bq20z90 Errata for EVM HPA155 Revision A ([SLUU234](#))

Figure 1. Components Required to Modify the Current bq20z90-EVM from Rev A to Rev B

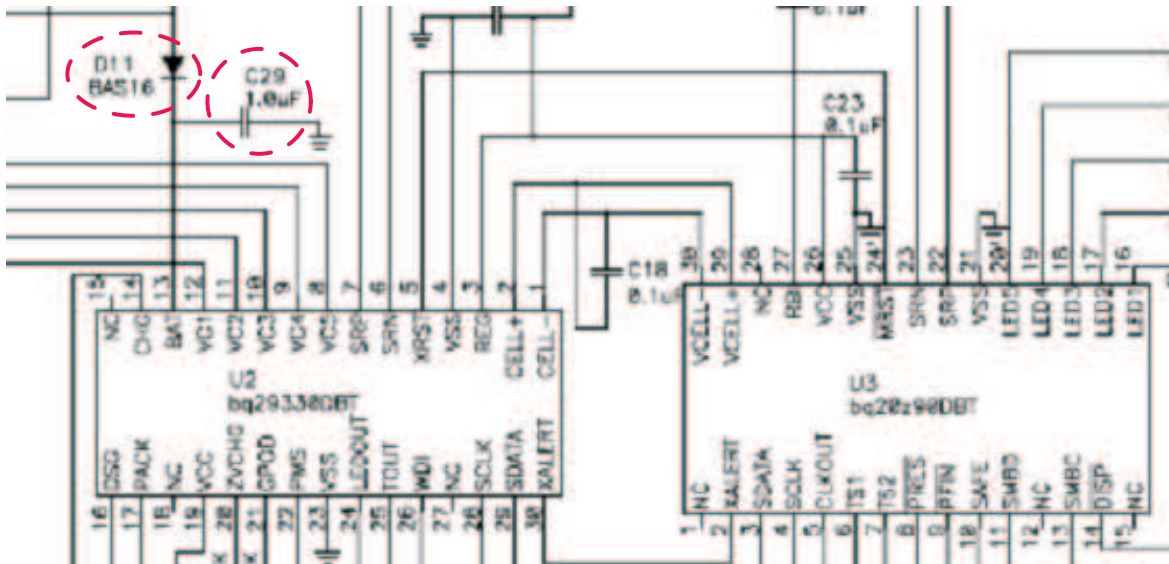
The bq29330 AFE may not respond correctly to a short circuit event when using 2-series or 3-series cell configurations, which have low cell impedance. Unwanted reset of the gas gauge, and DSG FET damage may result. 4-cell applications respond correctly.

For evaluation of short circuit protection with a 2-cell or 3-cell packs, it is recommended that the board be modified to include a 1- μ F / 25-V capacitor from the BAT pin (13) to ground, and a series diode isolating the BAT input from the battery. This is accomplished by cutting the trace to pin 13, and mounting the additional components nearby.

Texas Instruments is committed to modifying the EVM to revision B, which adds the diode / capacitor network. Also, the value of capacitor C15 will change from 4.7- μ F / 16-V to 1- μ F / 25-V.
